RE: RESPONSE TO IESC ADVICE ON THE MAXWELL PROJECT (SSD-9526)

WRM WATER AND ENVIRONMENT LETTER
MAXWELL PROJECT SURFACE WATER ASSESSMENT – RESPONSE TO IESC COMMENTS

Maxwell Project Surface Water Assessment

Response to IESC comments

Figure 3.6 - Derived flow-duration relationship for Saddlers Creek at Bowfield (1956-1981)

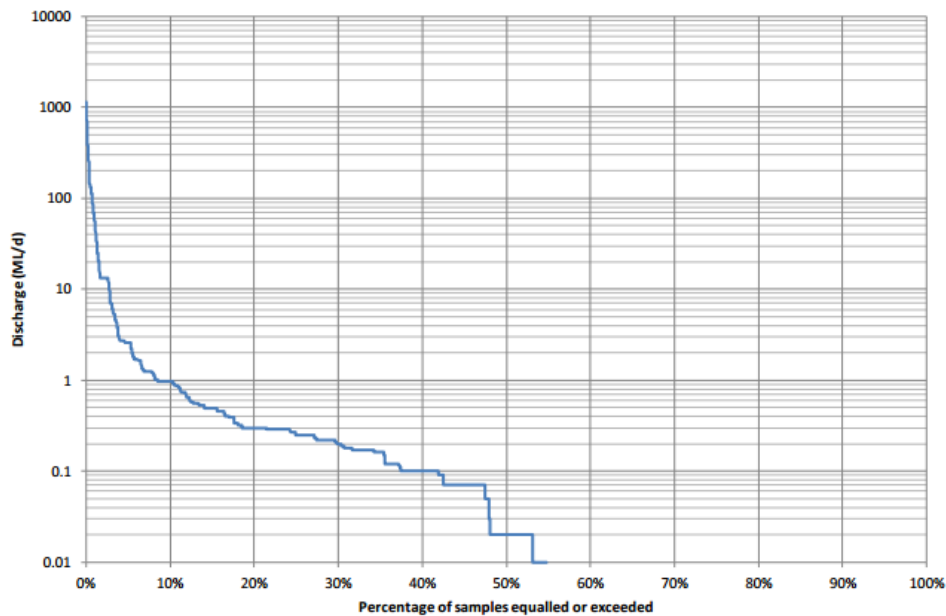
- Quantitative estimates of all surface water losses resulting from subsidence should be provided. This should include analysis of the impacts on the flow regime, including increases in the duration and number of low- and zero-flow days as these changes may affect instream and riparian biota (e.g. Swamp Oaks, *Casuarina glauca*) along Saddlers Creek and other waterways. Ponding may also adversely affect existing vegetation and recruitment (e.g. through waterlogging).

Review of the historical flow data for Saddlers Creek at Bowfield between 1956 and 1981 (see Figure 3.6 from the Surface Water Assessment, reproduced below) shows that the Saddlers Creek is highly baseflow driven, with the majority (approximately 90%) of recorded flows being below 1 megalitres per day (ML/d) (11.6 litres per second [L/s]). This indicates that most of the time, flow in Saddlers Creek is driven by groundwater flows (rather than surface flows). As such, any increases in ponding or surface fracturing resulting from subsidence would be unlikely to have an impact on the number of low- and zero-flow days in Saddlers Creek. In addition, the Groundwater Assessment (HydroSimulations, 2019) concluded that the Project would have zero impact on baseflow in Saddlers Creek.

Figure 5.1 - North Void water level - climate change assessment

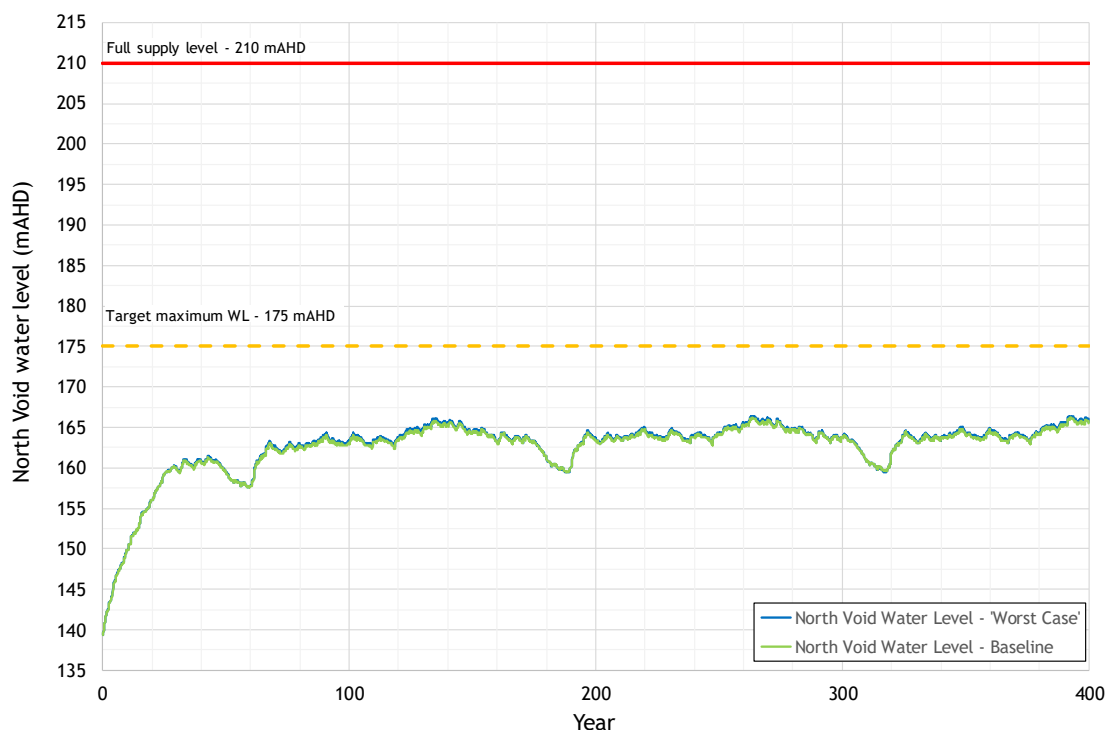
- use of SILO data implicitly assumes that future average climatic conditions will be identical to the past and is inconsistent with the use of NARCLiM climate projections utilised in the groundwater assessment. The majority of global climate models project warmer and drier conditions for this region (e.g. CSIRO, 2012). It is prudent to assess the performance of the site water management system under these projected changes, where factors required to adjust historic climate series by simple scaling can be obtained from the NSW Climate Data Portal (NSW Government 2019a) or the Australian Climate Futures tool (CSIRO and BOM 2019).

The impact of the potential changes in rainfall and evapotranspiration for the proposed final voids are presented in Figure 5.1, Figure 5.2 and Figure 5.3. The results show the following (with the baseline results shown for reference):

- North Void: The equilibrium and peak water level are less than 0.5 m higher than under baseline climate conditions.
- East Void: The equilibrium and peak water level are less than 0.5 m higher than under baseline climate conditions.
- South Void: The equilibrium and peak water level are less than 0.5 m higher than under baseline climate conditions.
